Subject: RAI Letters
Creation Date: 7/27/04 12:02PM
From: Nanette Gilles

SUBJECT: REQUEST FOR ADDITIONAL INFORMATION LETTER NO. 4 - EXELON EARLY
SITE PERMIT APPLICATION FOR THE CLINTON ESP SITE (TAC NO. MC1122)

Exelon Early Site Permit Application
Site Safety Analysis Report (SSAR) Section 2.3, Meteorology
Requests for Additional Information (RAI)

RAI 2.3.2-3

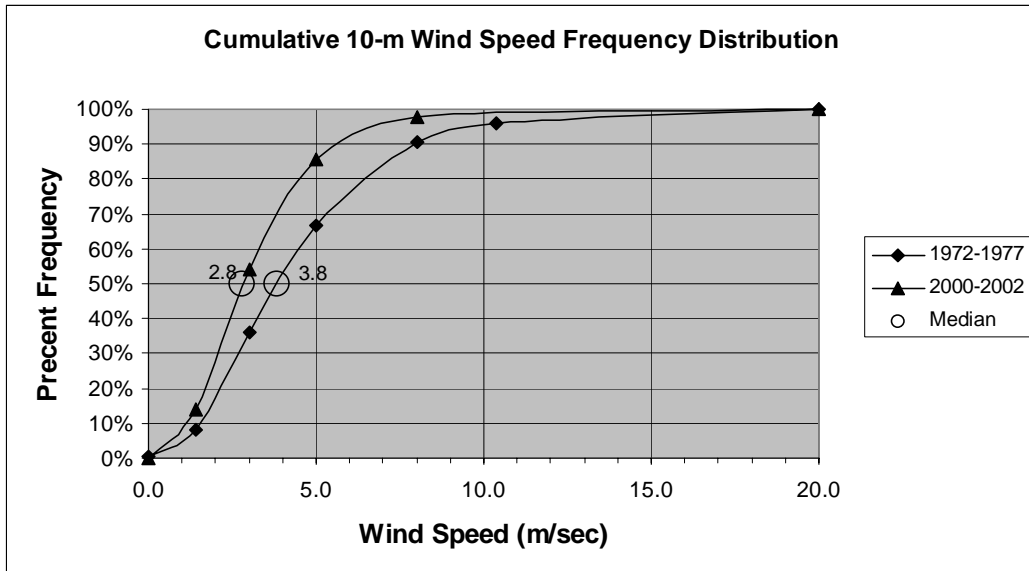
The onsite 10-m wind speed frequency distributions presented in SSAR Table 2.3-8 show a general shift towards lower wind speeds in the more recent data. In particular, a plot of cumulative wind speed frequency distribution shows a median (50 percent) wind speed value of 2.8 m/sec for the 2000-2002 period of record as compared to a median wind speed value of 3.8 m/sec for the 1972-1977 period of record. Please explain what might have caused these differences in reported wind speed frequency distributions between these two periods of record.
